**MONITORING YEAR 0
ANNUAL REPORT
FINAL**

BUG HEADWATERS MITIGATION SITE

Subject: Draft MY0 Report Review
Bug Headwaters Mitigation Site, Wilkes County
Yadkin River Basin: 03040101
DMS Project ID No. 100084
DEQ Contract #. 7617

1.18

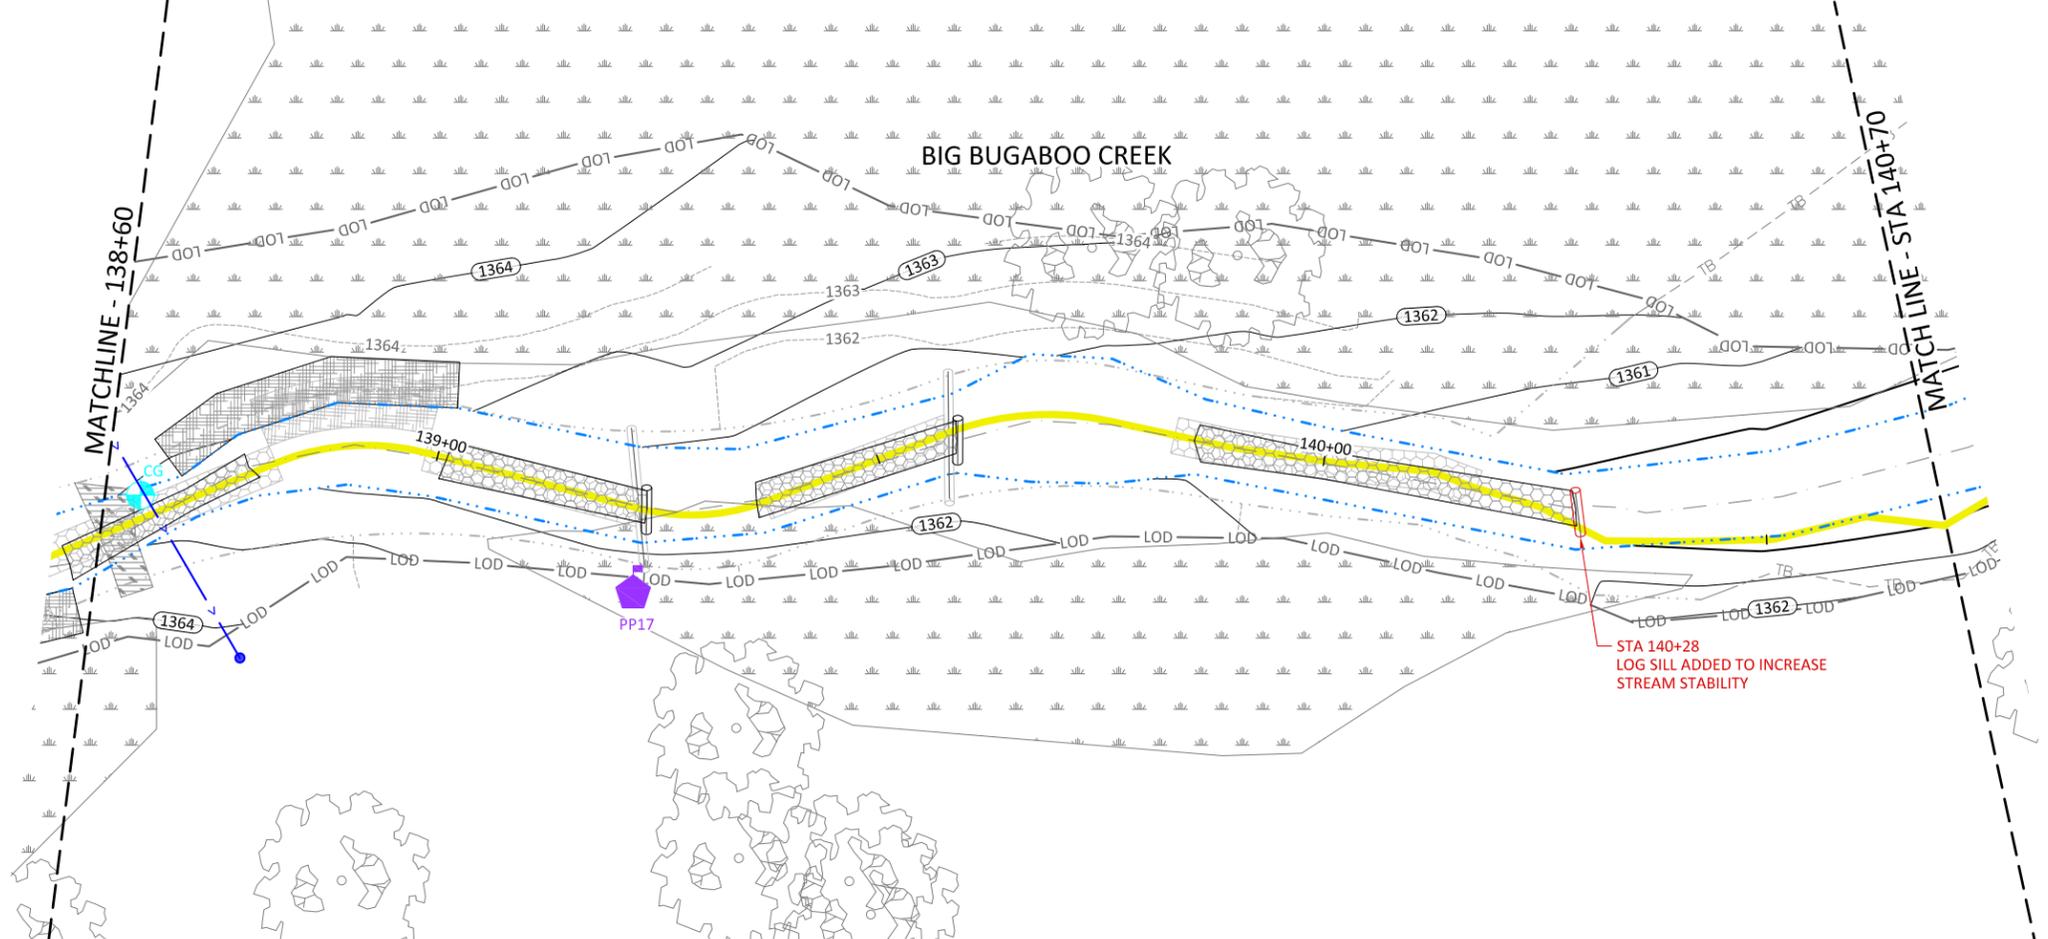
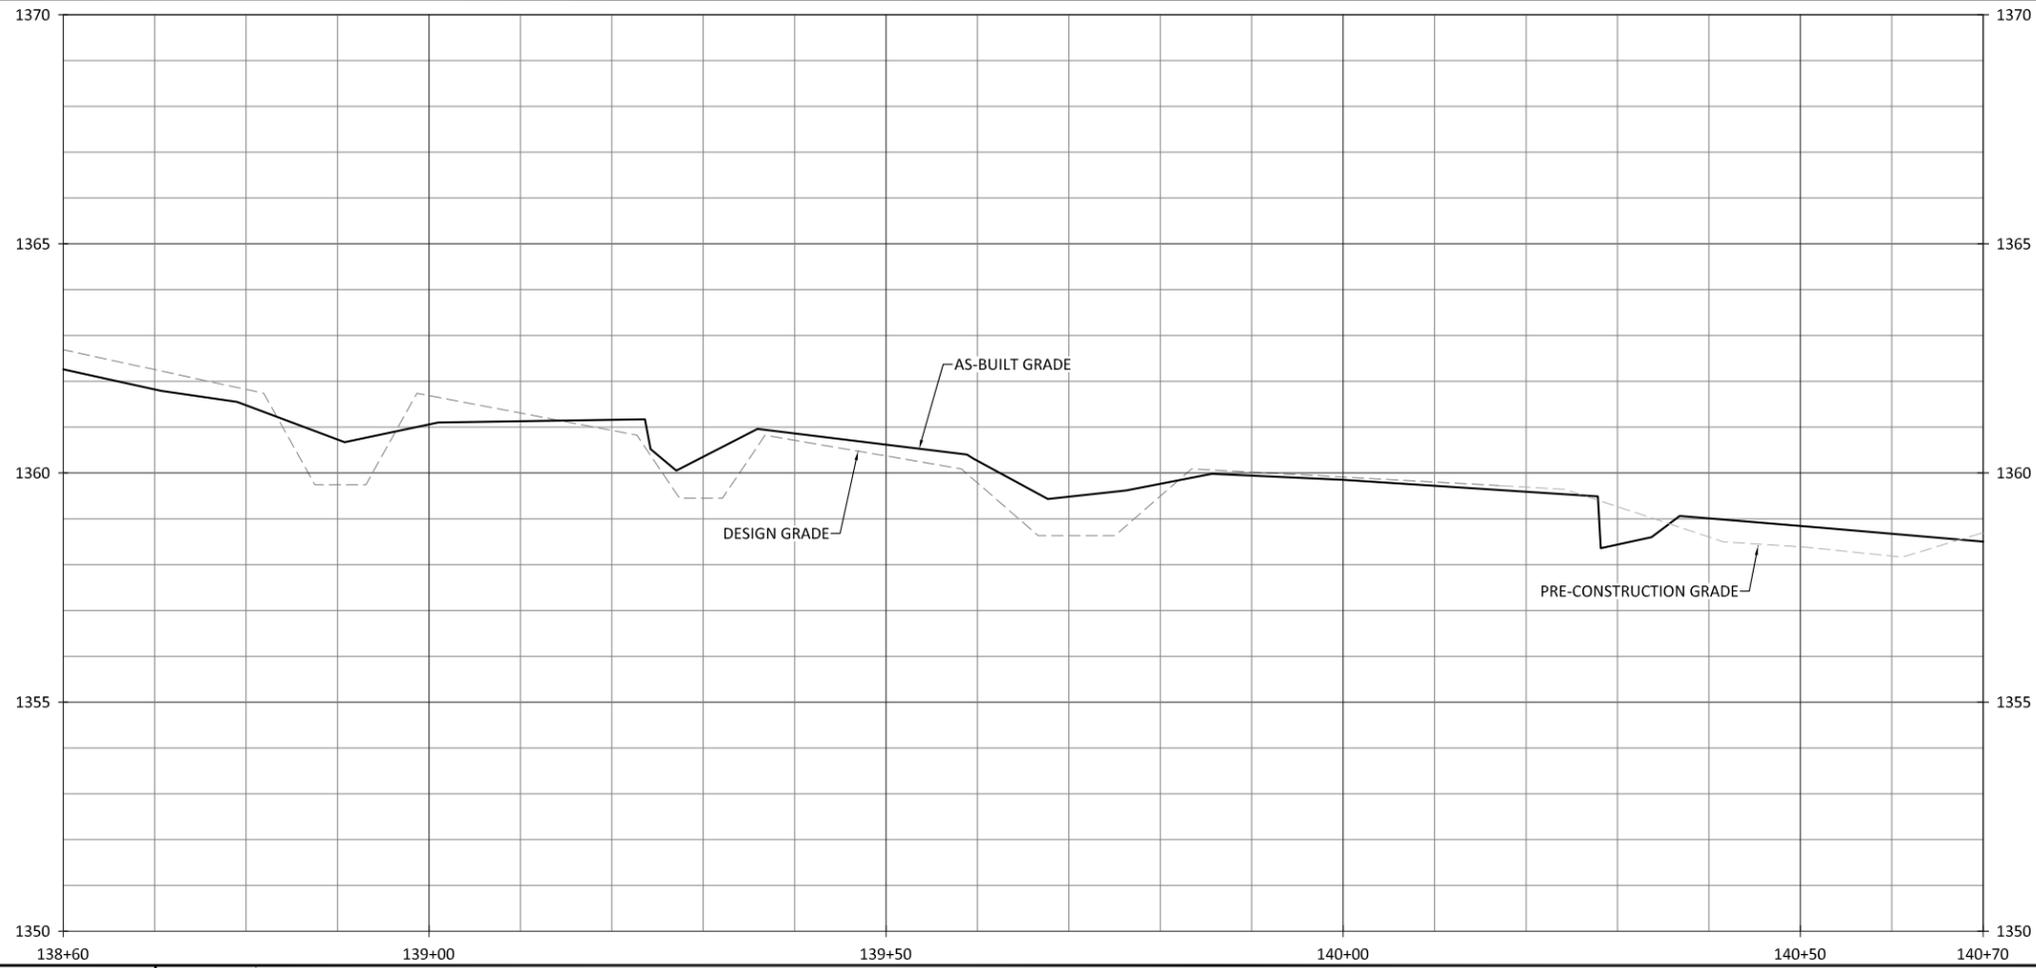
Sheet 1.17 and 1.18: Symbol for "asbuilt culvert" is shown on each sheet. Please revise or explain.

Response: The two "as-built culvert" symbols have been removed.

1.21
 Sheet

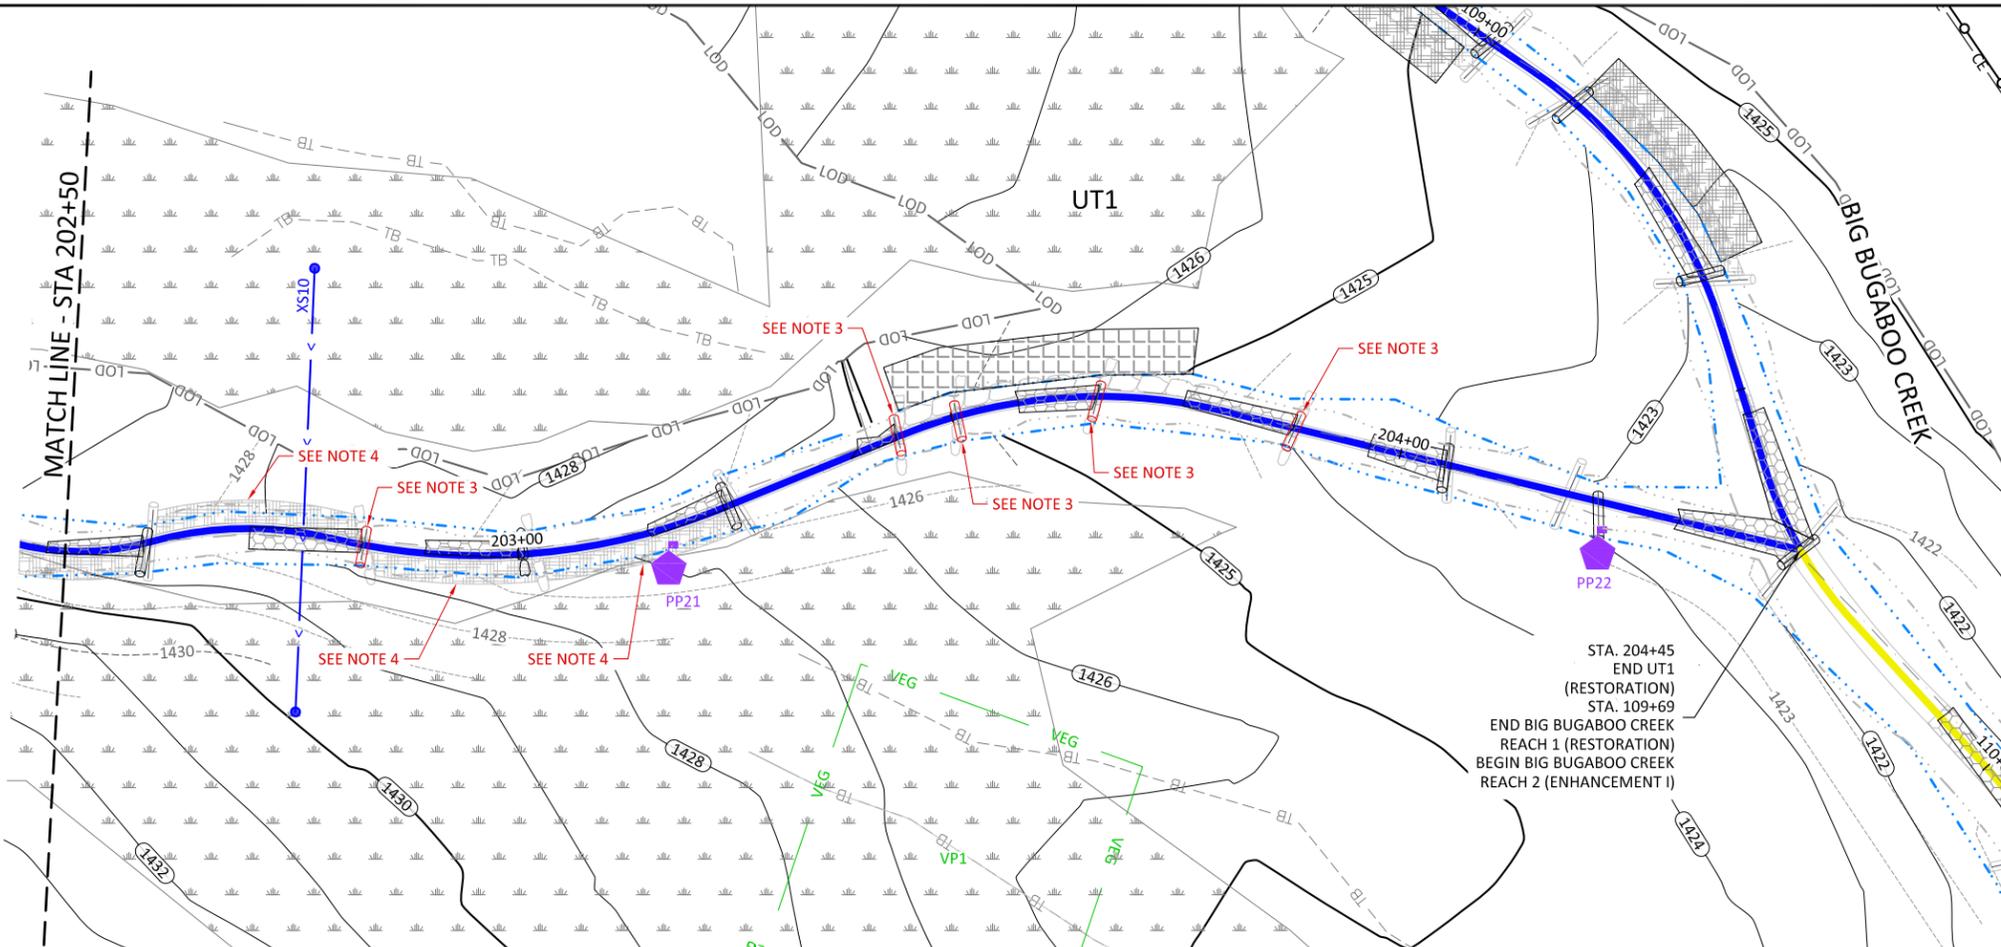
Sheet 1.21: Note indicates riffle at 201+36 is covered in sediment and will be repaired or maintained as needed. Please add call out to CCPV and provide update in MY1 report.

Response: A callout has been added to the CCPV and an update will be provided in MY1.

1.34

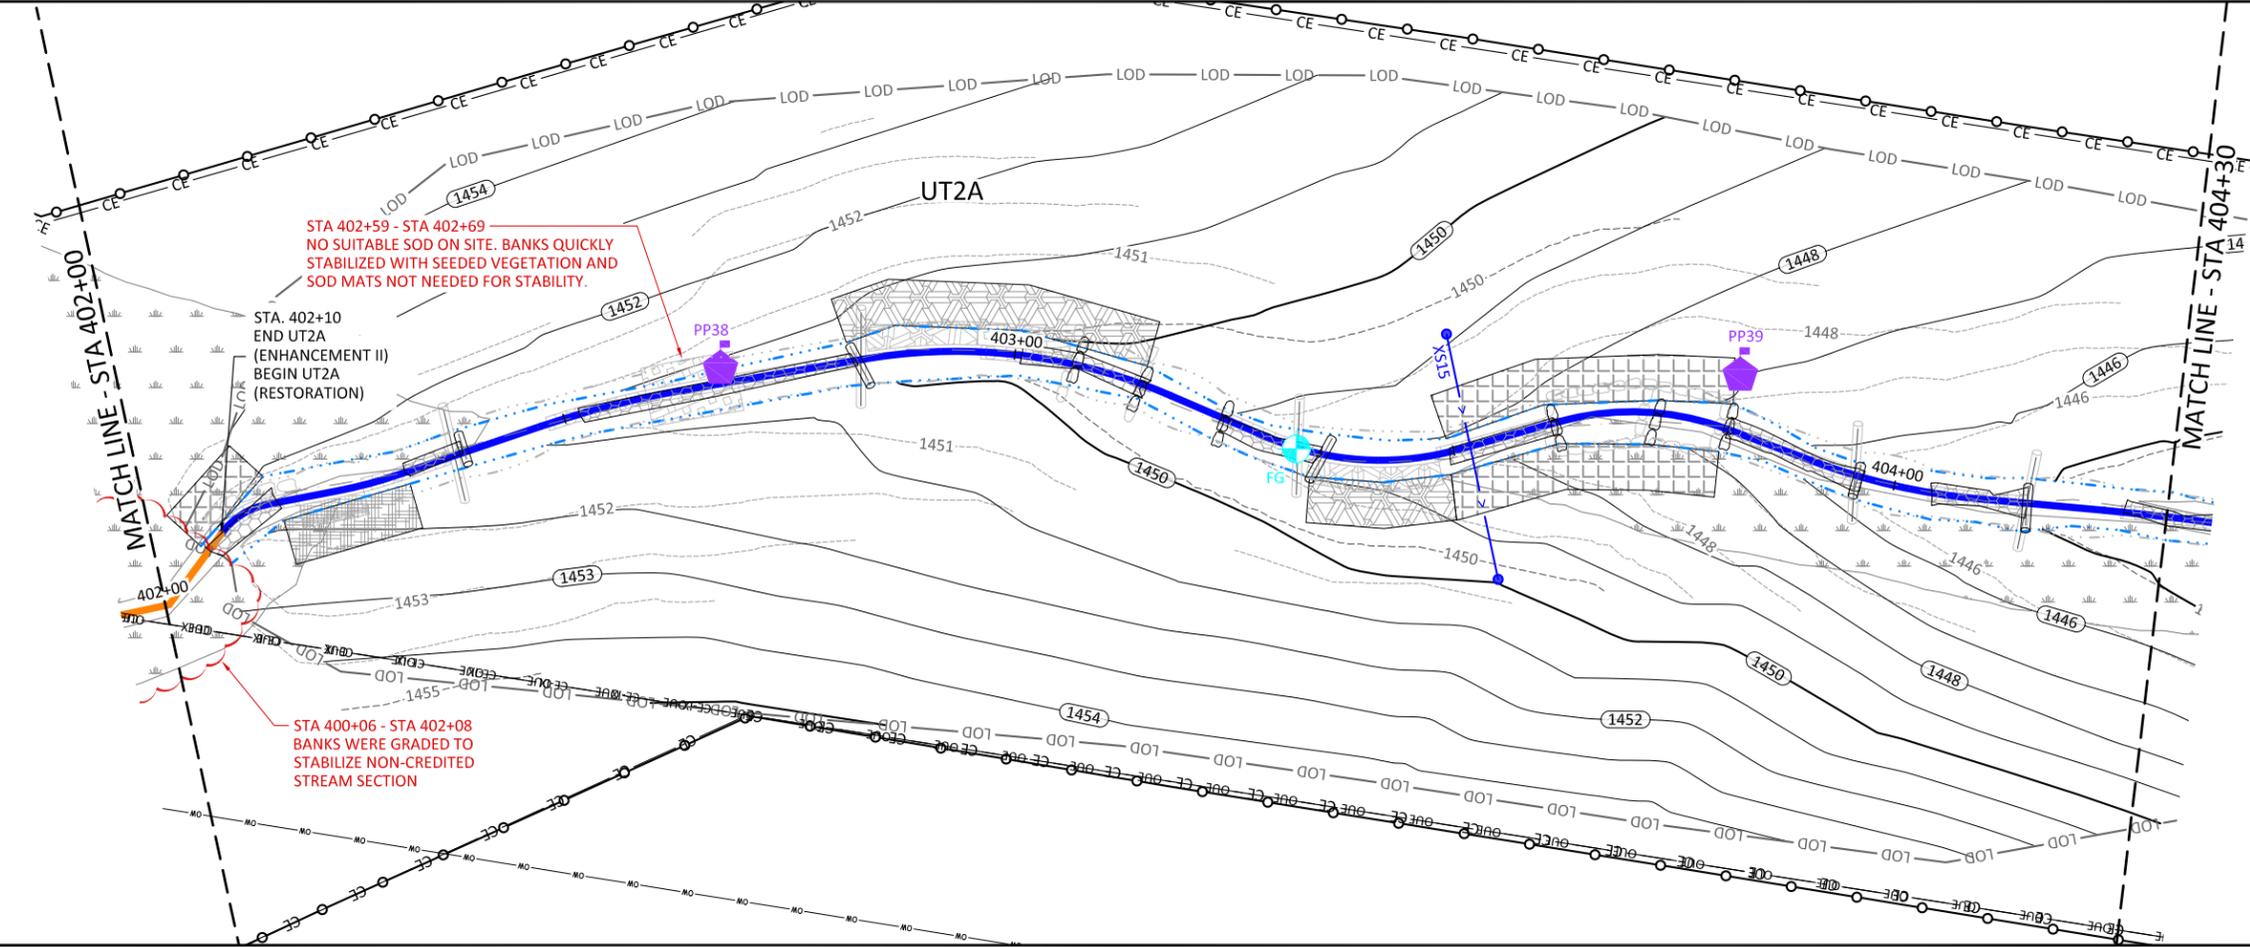
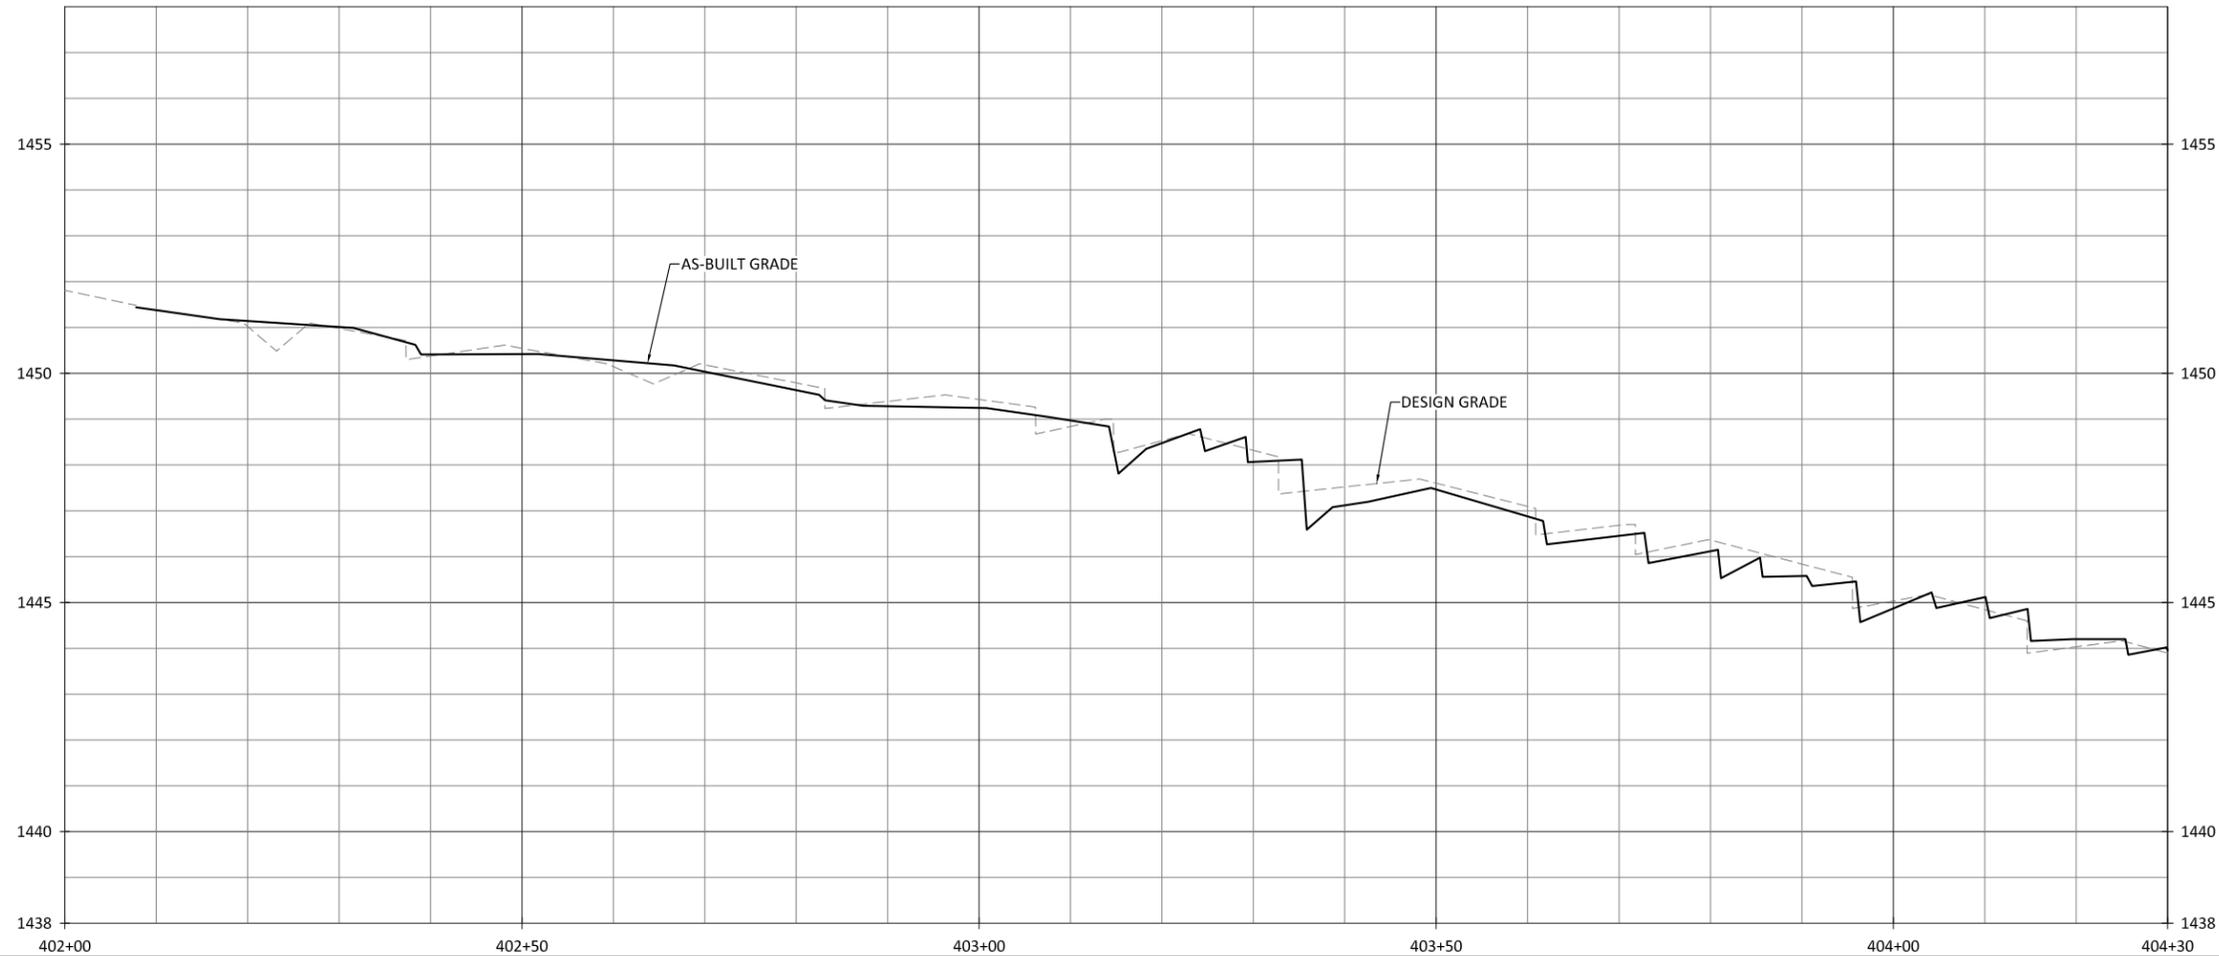
Sheet 1.34: PP27 is incorrectly labeled. It should be PP37.

Response: PP27 labeling has been updated.
